Utility Patent  
Ser. No. 09/742,835

For: Weed Extraction Apparatus

**Request for Correction to the Drawings Under 37 CFR § 1.123**

**In Figure 1:**

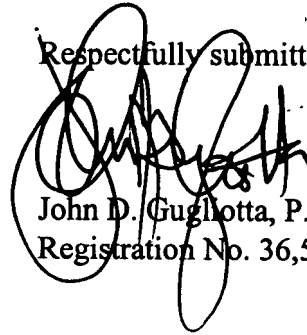
As requested and shown, please delete reference numeral "62" as indicated. Also, add the extension of the handle 20, as shown in red, so that the handle extends just below the joint in which bolt 35 connects the two arms of the claw appendages 30.
